AMENDMENTS TO THE DRAWINGS:

REMARKS

FIG. 2B

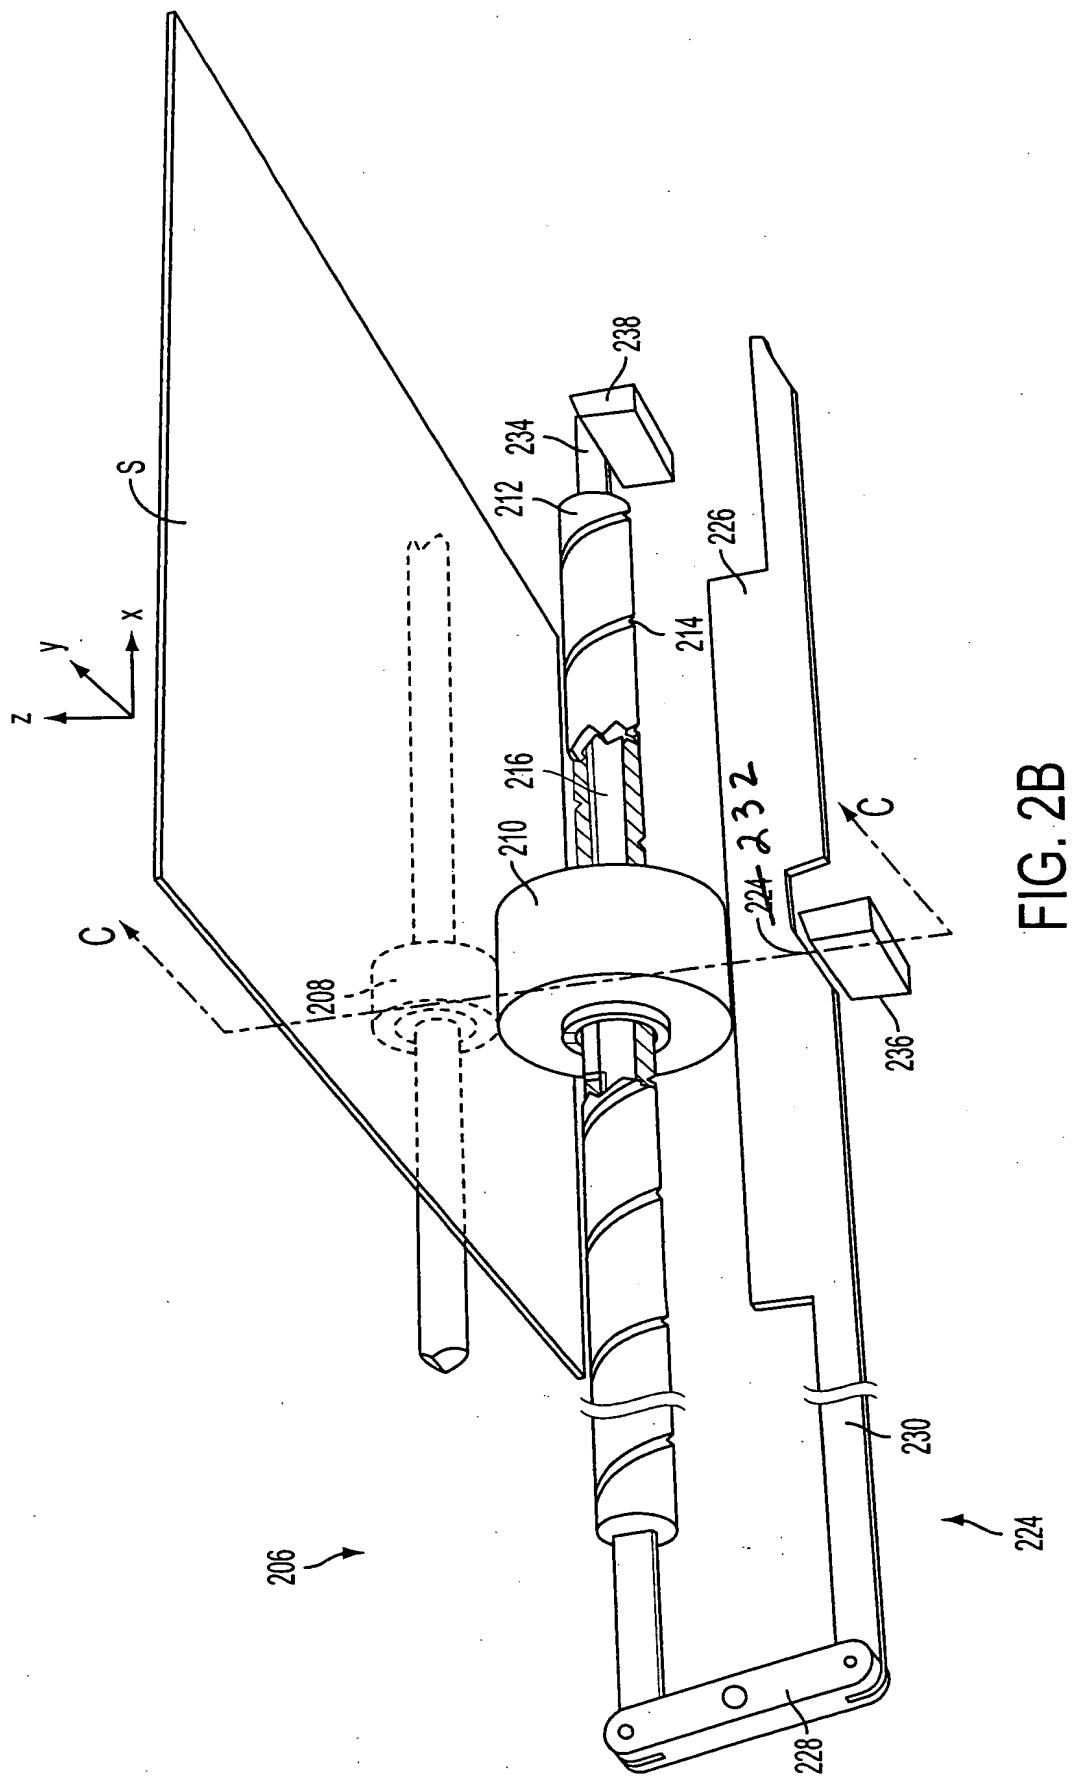
Attached herewith are replacement sheets for Figure 2B and for Figure 3. In Figure 2B, the label "224" with respect to the ramp of the arm 230 has been relabeled --232--, consistent with Figure 2A. Figure 3 has been labeled "PRIOR ART".

In numbered paragraphs 2-5 on page 2 of the Office Action, minor objections were raised with respect to the drawings. By the attached replacement sheets submitted herewith, Figures 2B and 3 have been revised to address the Examiner's concerns such that withdrawal of these objections is respectfully requested.
